# MEMO

<b>To:</b>	<b>NZ Clean Energy Ltd, Attn: Tracey Morse</b>	<b>Date:</b>	<b>07.03.25</b>
<b>From:</b>	<b>Joshua Raynes – Environmental Engineer</b>	<b>CC:</b>	
<b>Reviewed:</b>	Bronwyn Rhynd, Environmental Engineer	<b>CKL Ref:</b>	<b>A23288</b>
<b>Re:</b>	<b>1352 Homebush Road, Darfield- RC245775- RFI response Earthworks &amp; OLFP</b>

# AGRIVOLTAIC FACILITY

## 1352 HOMEBUSH ROAD, DARFIELD

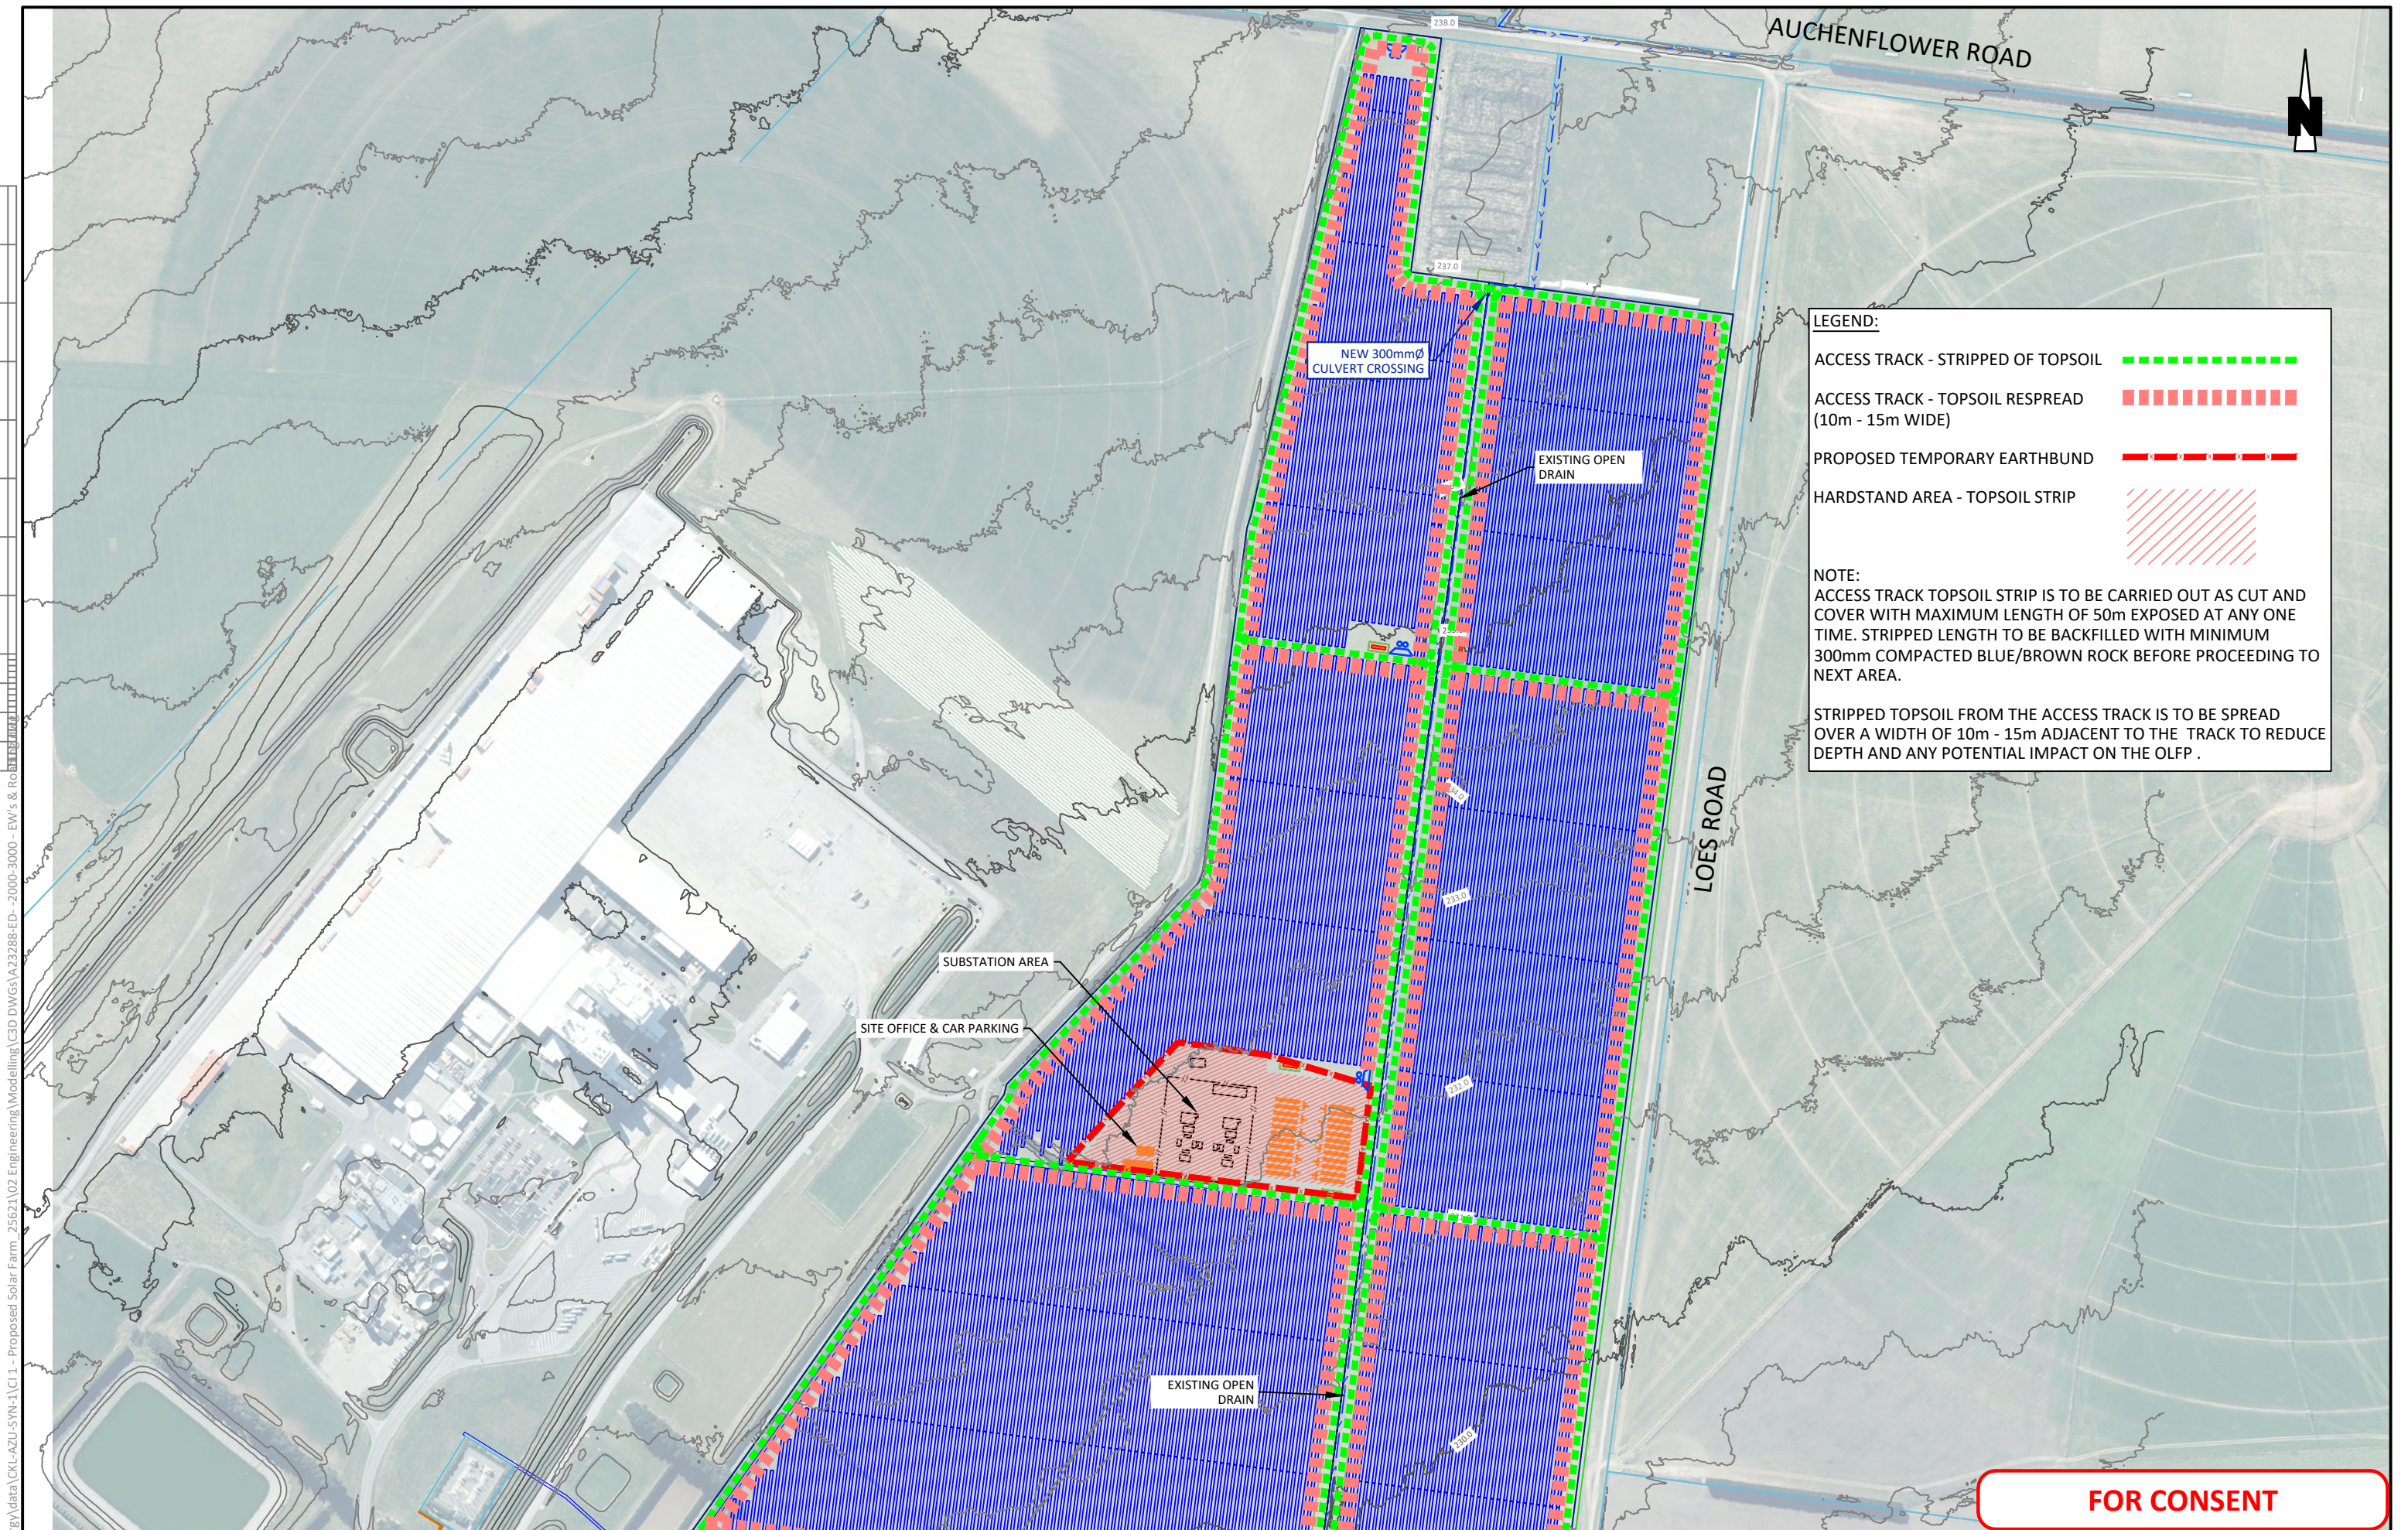
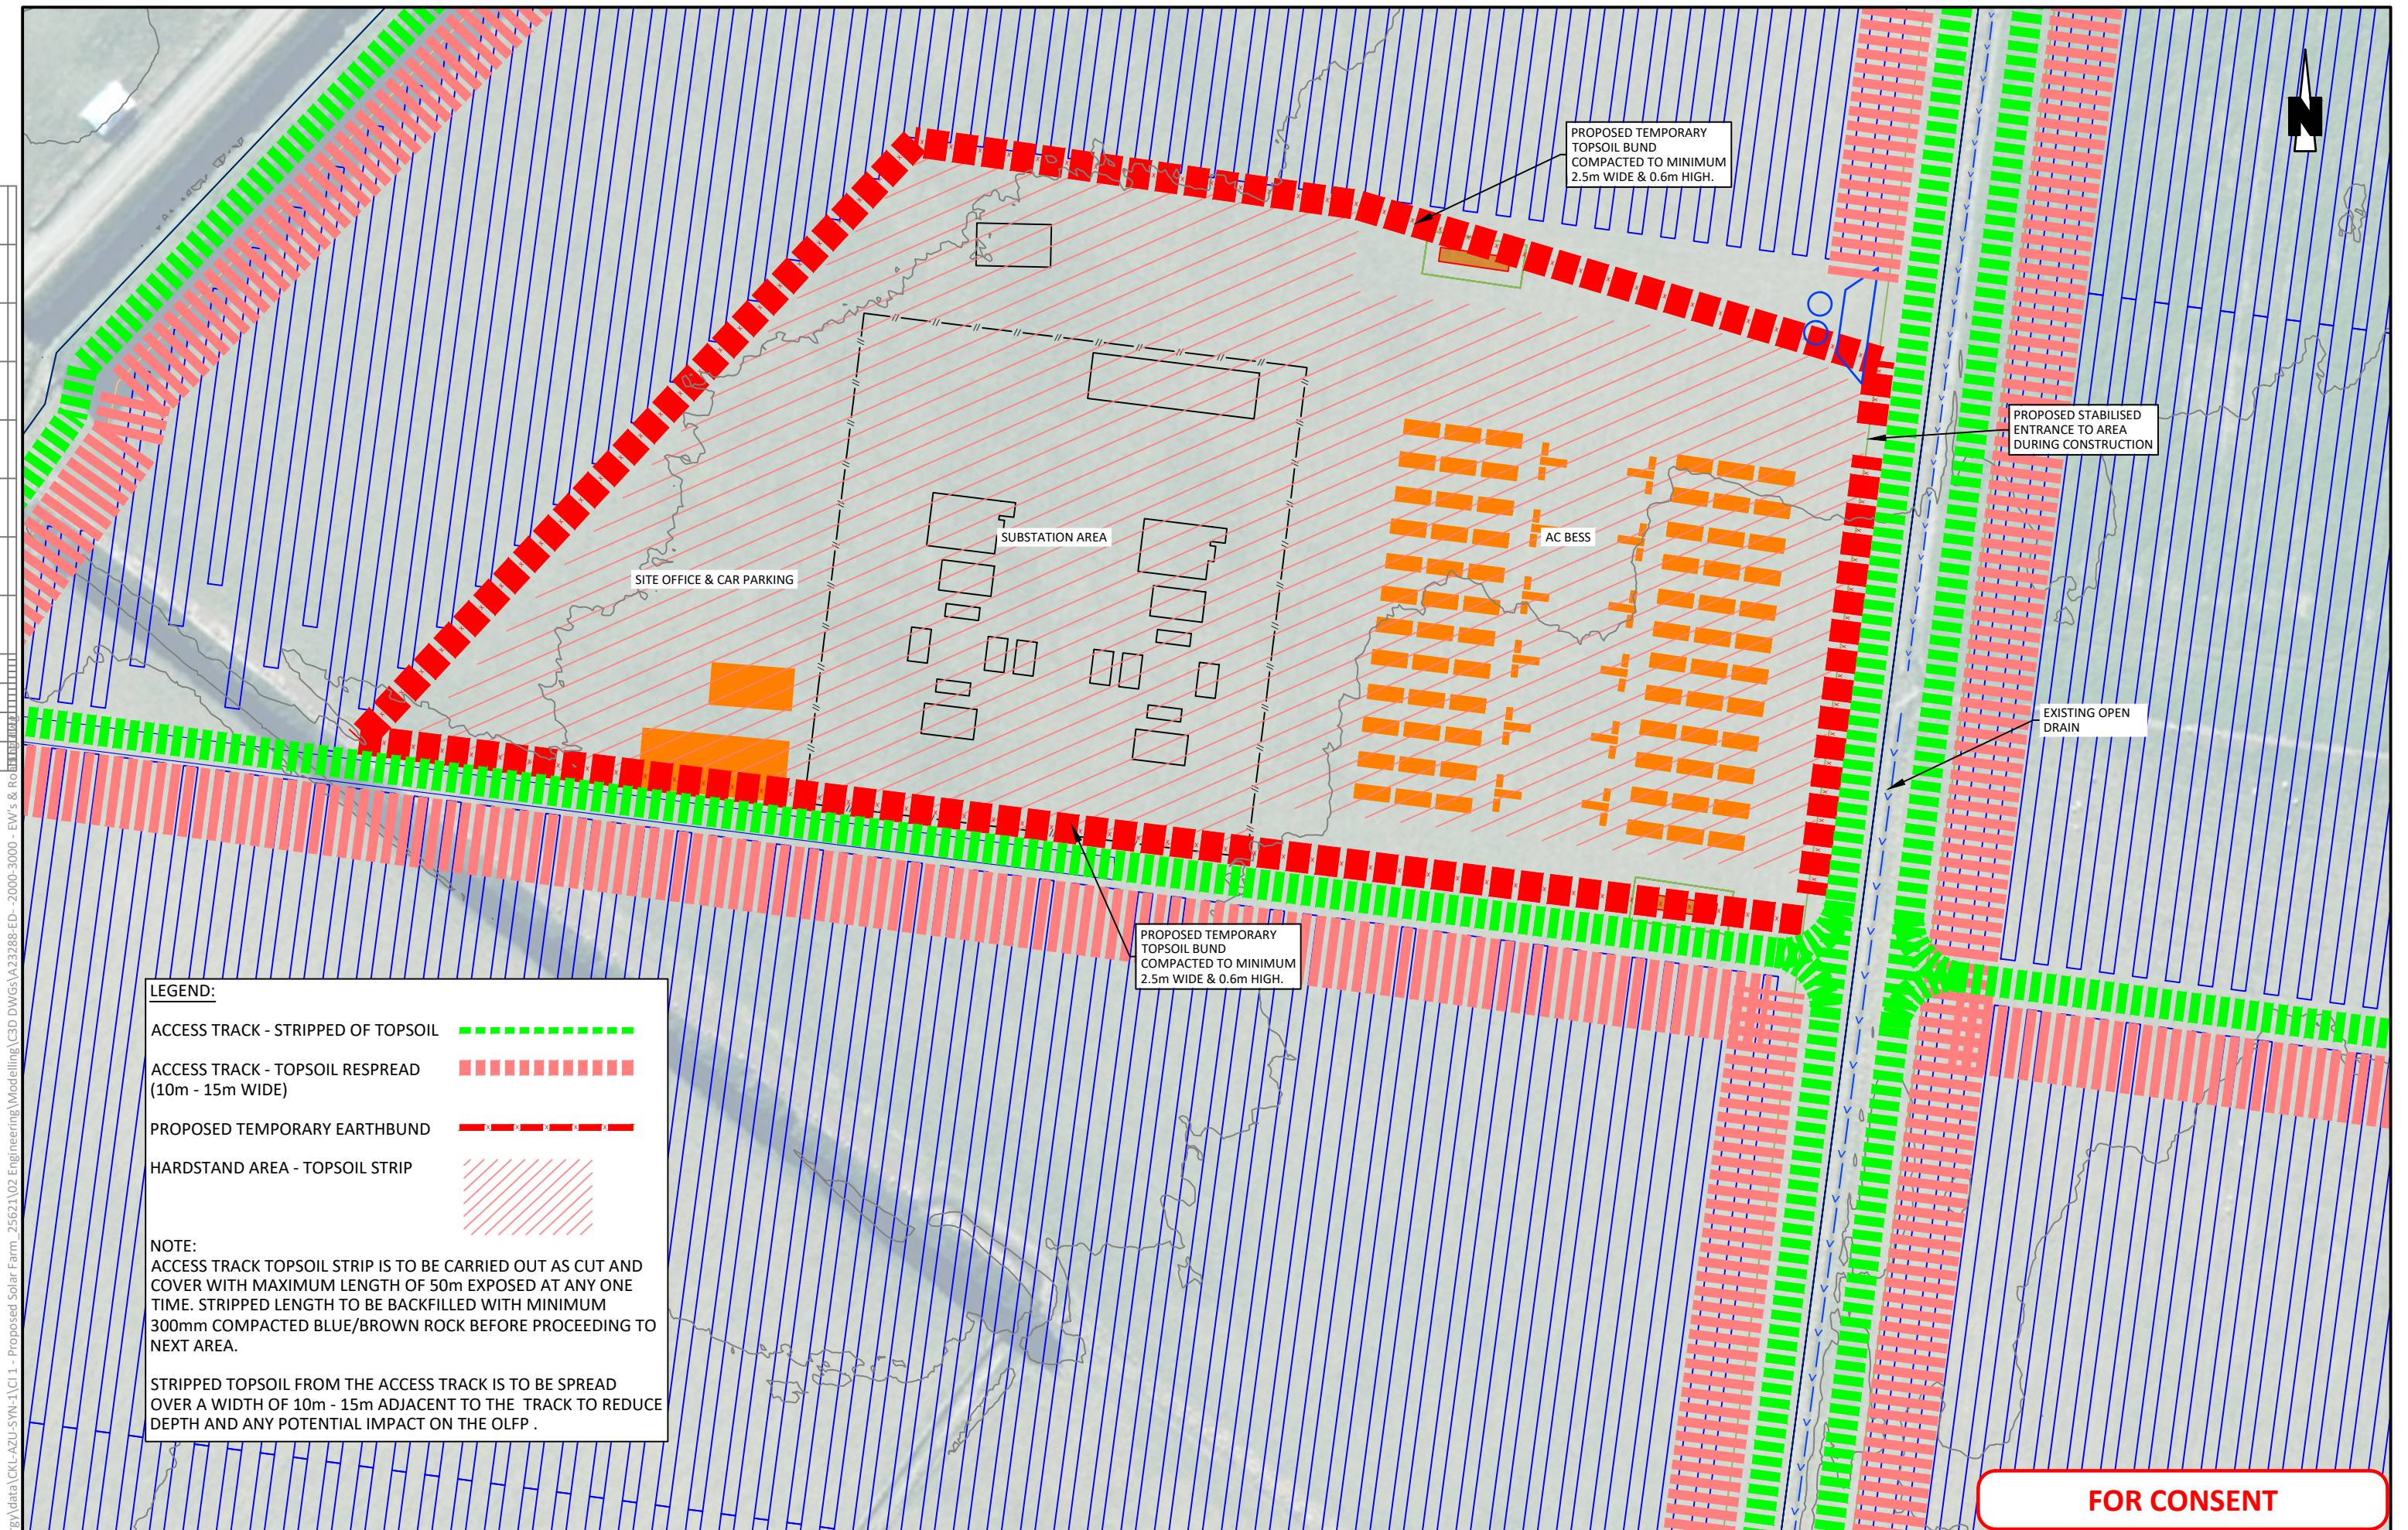
- 1. Please provide a net cut to fill plan to confirm that no changes to land drainage patterns will result from the proposed earthworks*
- 2. In the event that the result are not zero, please provide further information regarding how this will be addressed”*

The proposal for the earthworks includes areas of stripped topsoil for access tracks as shown in the CKL plans 2000-2002 & 3004. This stripped topsoil from the access track is to be spread over a width of 10-15m adjacent to the track to minimise the depth (of fill) and any potential impact on the OLFP that may be present in this area. This will result in approximately 100-150mm depth of topsoil being added to the existing natural ground level adjacent the access tracks. At this point in the design, i.e. prior to detailed design, a cut and fill plan is not deemed necessary due to the minor nature of the proposed earthworks and the minor fill depth.

STRIPPED TOPSOIL FROM THE ACCESS TRACK IS TO BE SPREAD OVER A WIDTH OF 10m - 15m ADJACENT TO THE TRACK TO REDUCE DEPTH AND ANY POTENTIAL IMPACT ON THE OLFP .
